Ancoats Mobility Hub

Ancoats Mobility Hub
Design and Access Statement Addendum
February 2023

This addendum document to the Design and Access Statement has been prepared by Buttress in conjunction with the professional team (listed to the right) to support a Minor Material Amendment application for the mixed use development known as the Mobility Hub.

The proposed development was granted planning approval on 30th July 2021 (Reference: 130627/FO/2021). Since this time Manchester City Council have appointed Bowmer and Kirkland as main contractor to deliver the scheme. The proposed amendments within this application have been developed in response to initial market testing on the delivery hub operator and construction supply chain, and initial building control advice.

2.3 Upper Parking Levels Updates

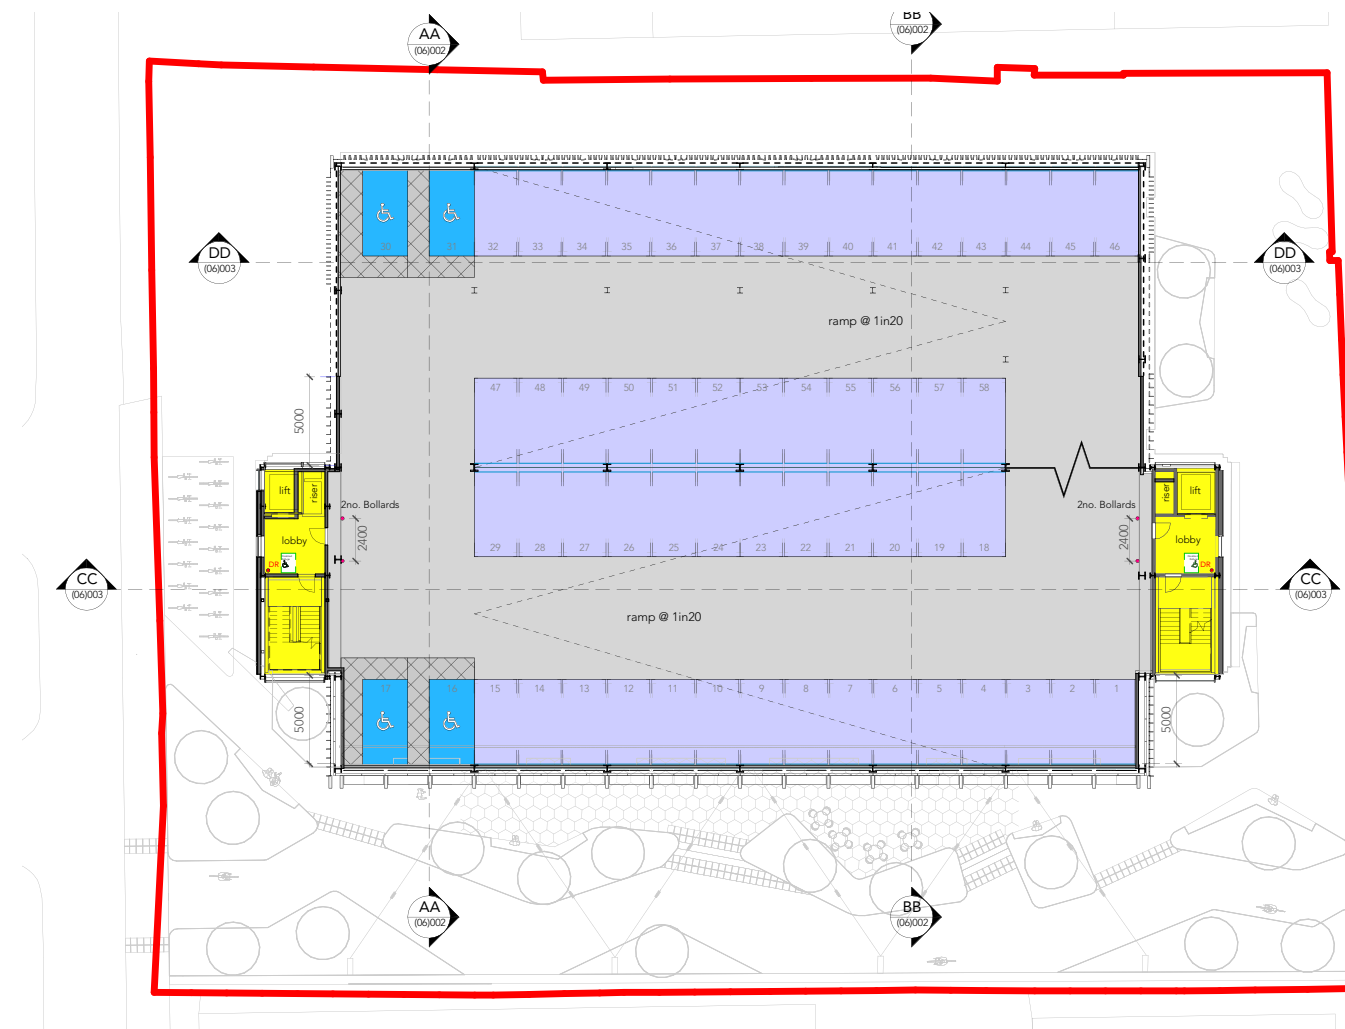
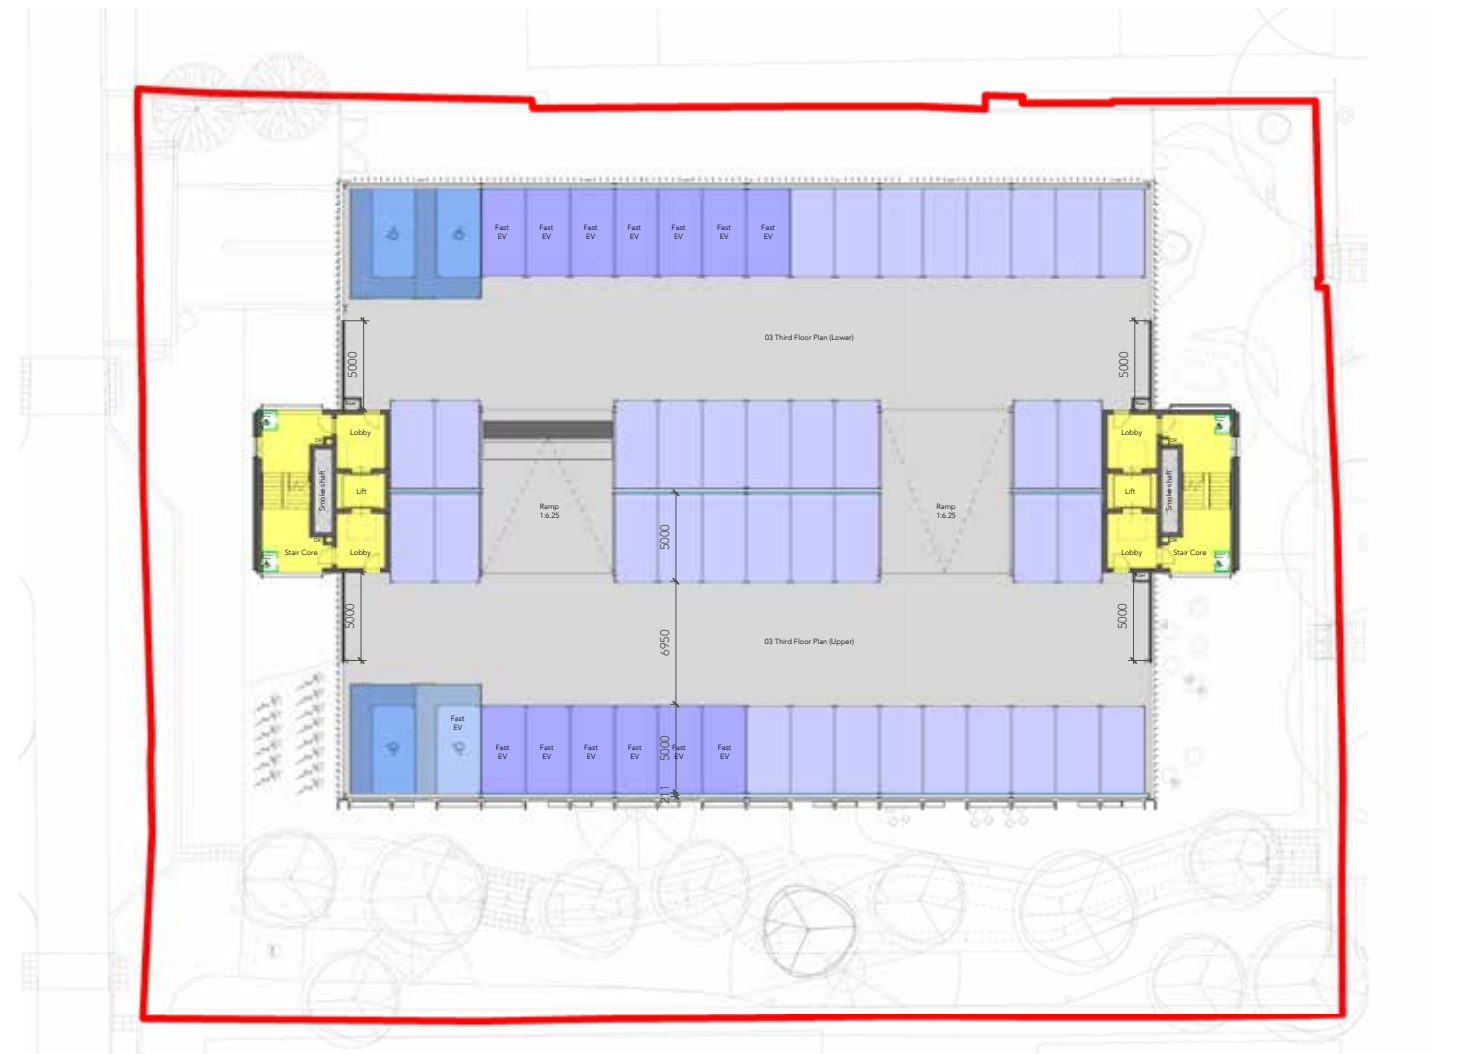
The planning approved layout utilised a circular ramp arrangement with parking located on ramped decks. Due to complexities in construction and coordination with the facade design this has been amended to a split deck arrangement with two central ramps connecting the levels.

- The split deck arrangement requires level access from both levels so the stair/lift cores have been moved centrally and dual access lifts incorporated.
- The carpark aisles have been increased to 6950mm in line with the IStructE guidance for two way ramps.
- The grid dimension between grid-lines A-B & B-C has increased to

17200mm due to increased aisle width.

- The location of Rapid and Fast EV chargers has been indicated to all levels.
- 6 no. motorcycle spaces included at Level 1.
- The total number of parking bays overall has been retained at 408 no.

2.4 Roof Plan Updates

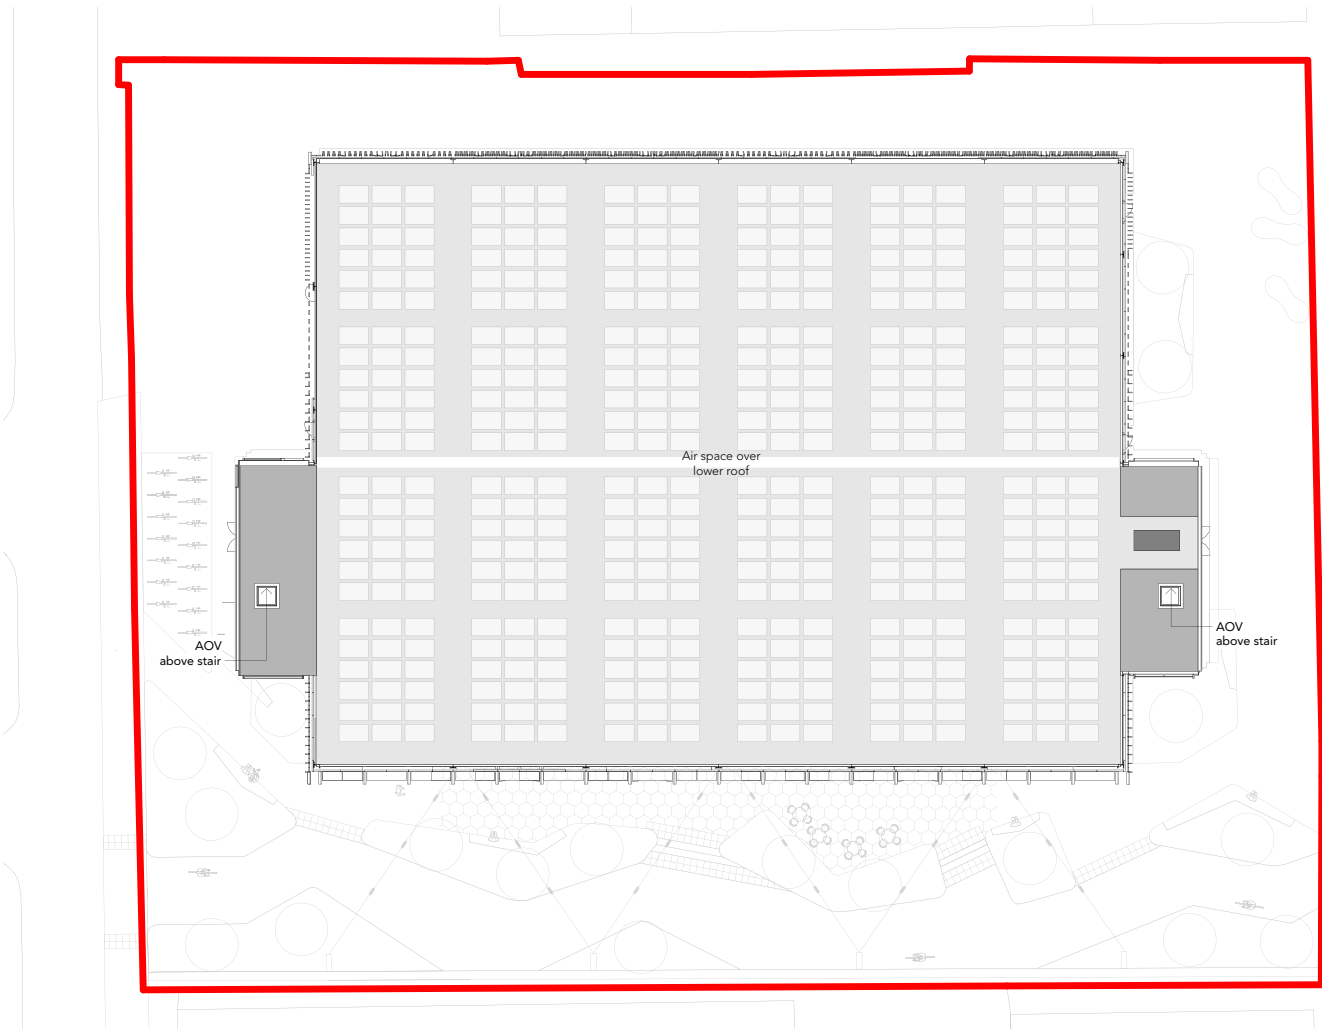
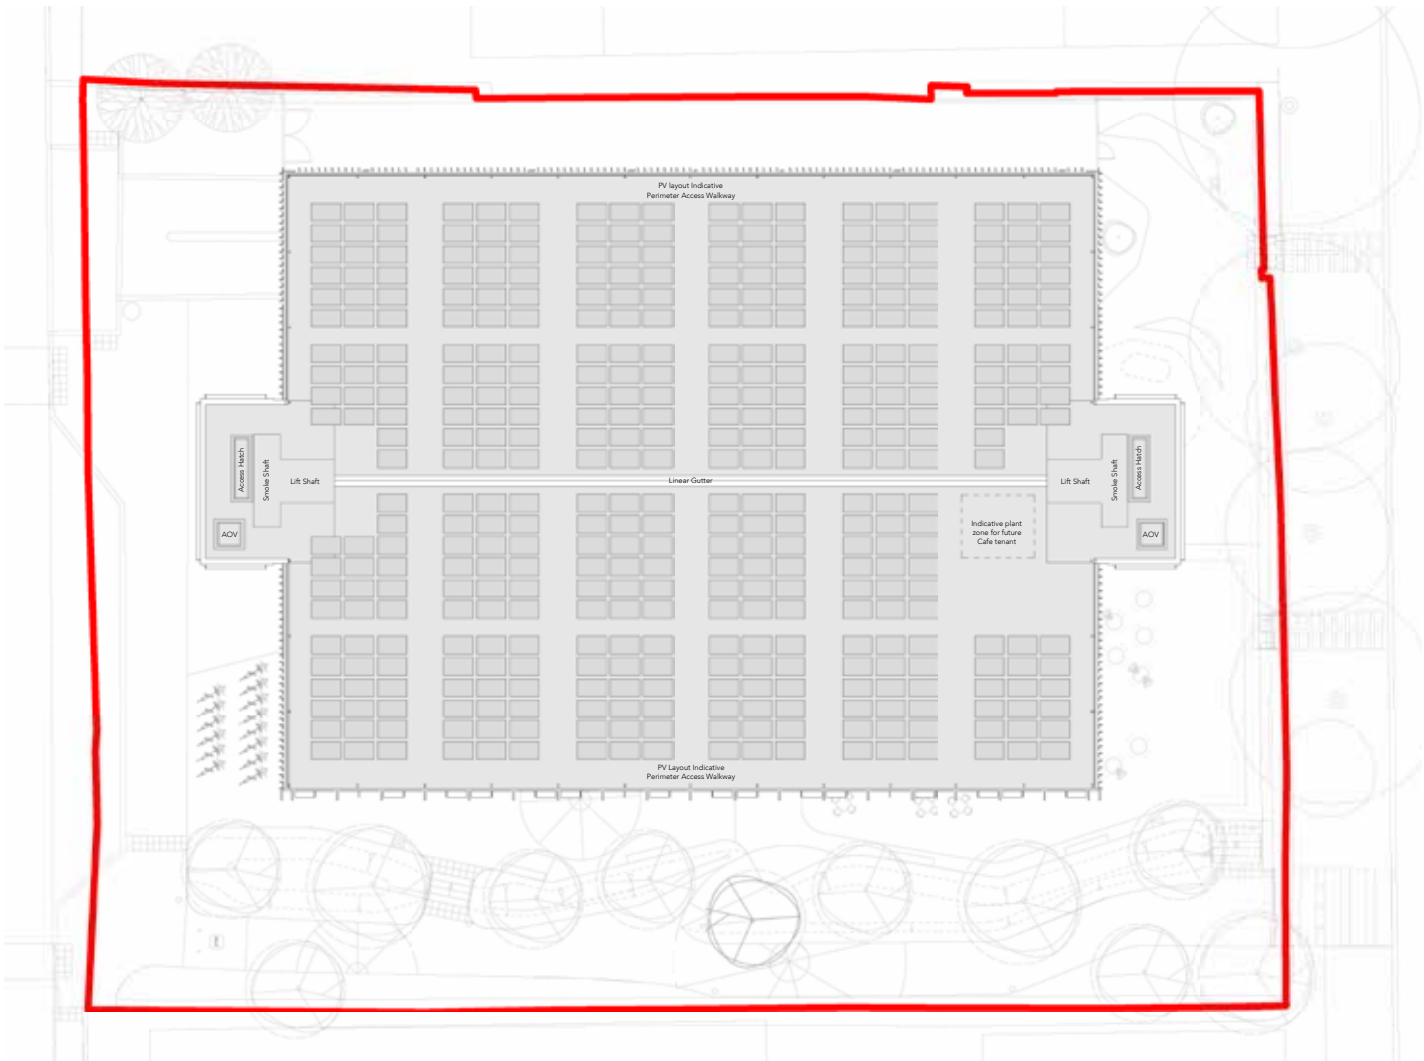
The roof plan remains largely unchanged and is still maximised with PV panels. The only update is the roof access arrangement which is now provided by an access hatch with fixed stair. The location of the smoke extract and lift overruns within the building footprint has resulted in a minor reduction in PV provision.

2.5 Massing Updates

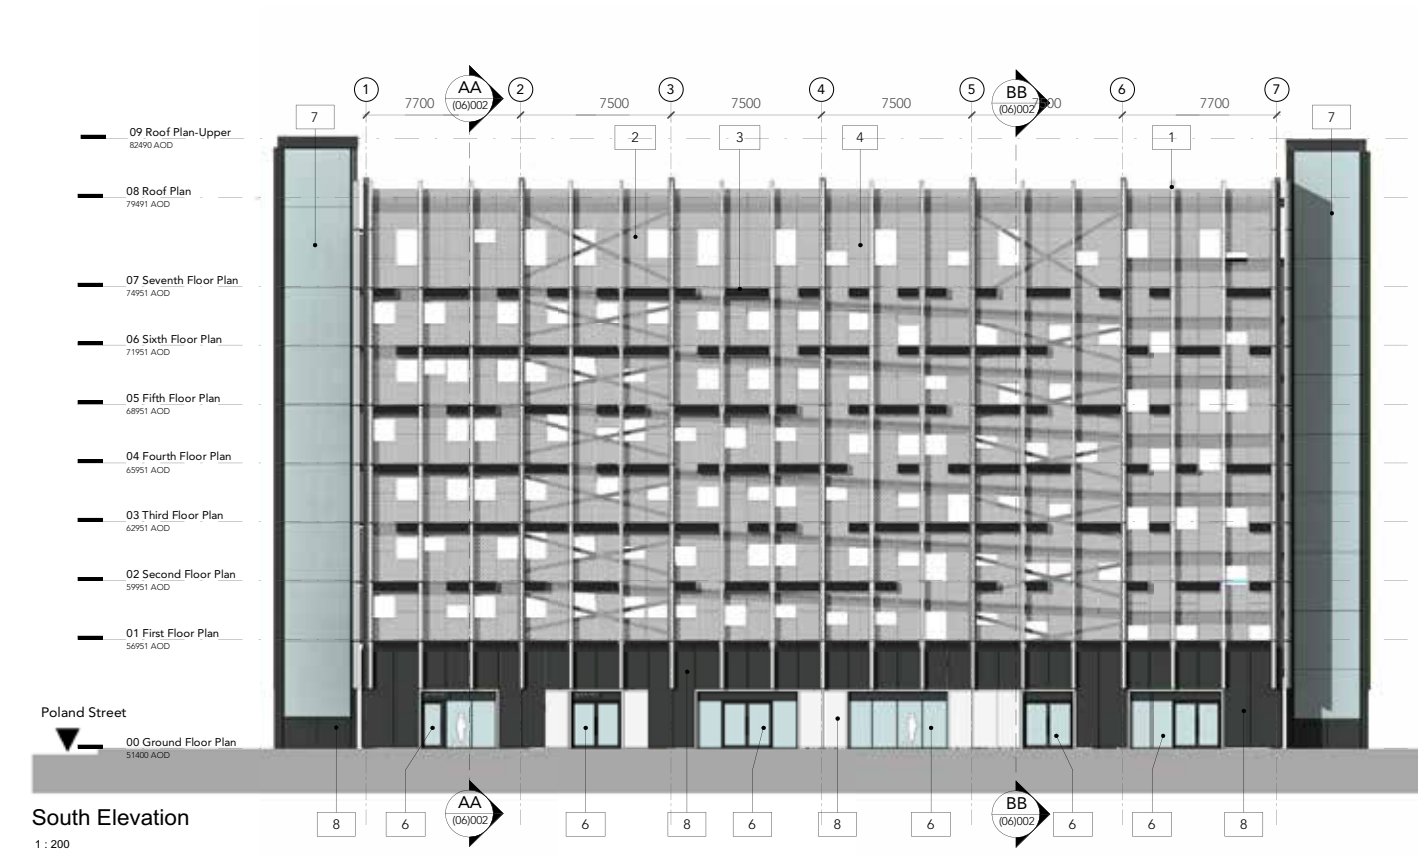
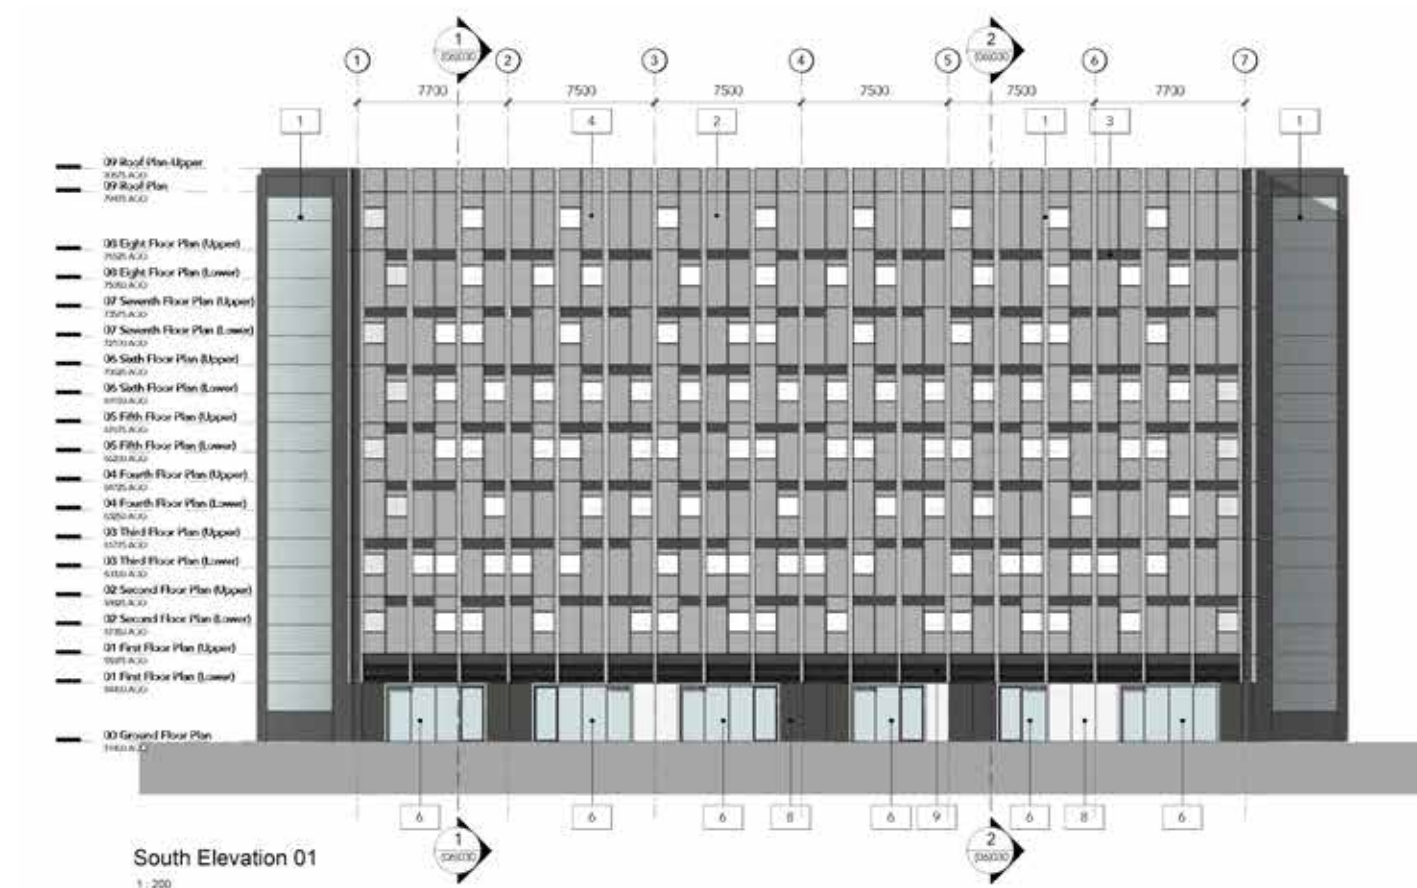
- The approved roof level is +79.491 and the proposed roof level is +79.475.
- Even though the height has been maintained the proposals now incorporates a further split level deck at Level 8. This has been achieved by the floor to floor of the carpark levels being reduced to 2950mm and the ground to first floor upper level being reduced by 1076mm due to the internal delivery route being removed.
- The stair cores have been reduced in height due to stair hatch access and aligns to the main building parapet level.

2.7 East Elevation Updates

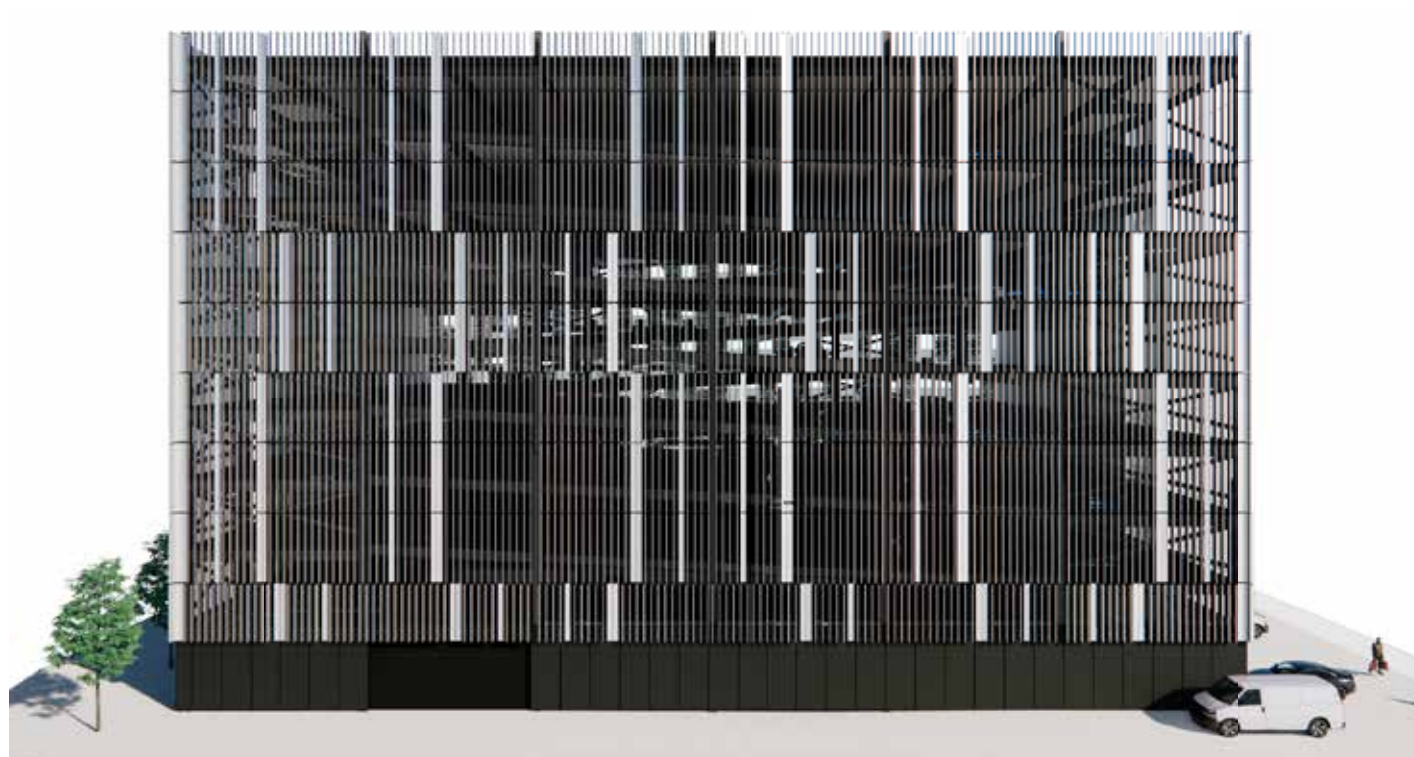
- The overall height of the elevation has been maintained but there have been minor amendments to the fin setting out due to the additional split level deck at Level 8.
 - The carpark core has been relocated centrally and a minor decrease in overall width in line with plan updates.
 - Fin size and fin spacing amended in response to design efficiency of facade elements.
- Shopfront incorporated adjacent to core providing a frontage onto Ancoats Green.
 - Stair core entrance provided adjacent to the core.
 - Minor amendments to position of service access and fire escape doors in line with plan updates.

2.8 North Elevation Updates

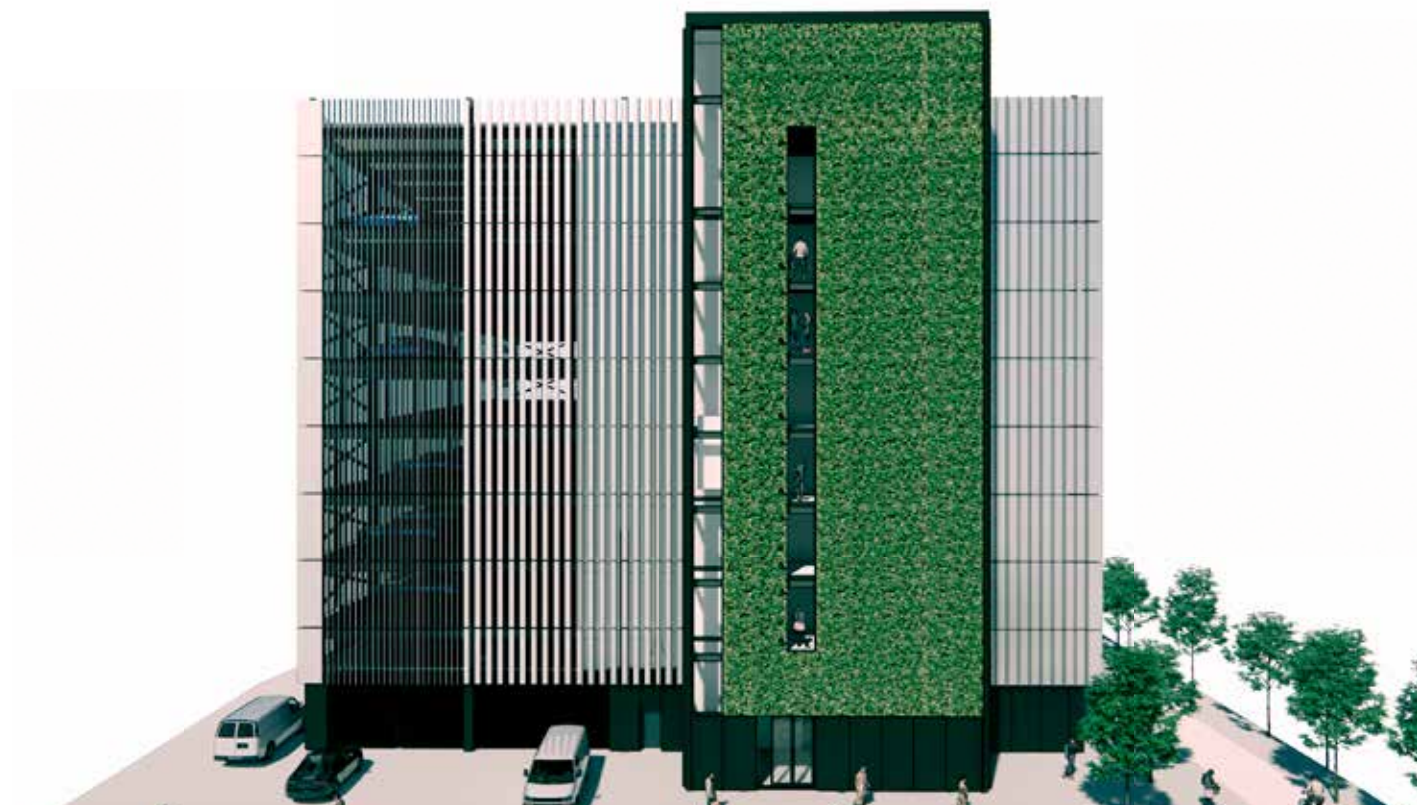
- The overall height of the elevation has been maintained but there have been minor amendments to the fin setting out due to the additional split level deck at Level 8.
- Fin size and fin spacing amended in response to design efficiency of facade elements.
- Roller shutter removed and new louvred door openings included in line with plan updates.
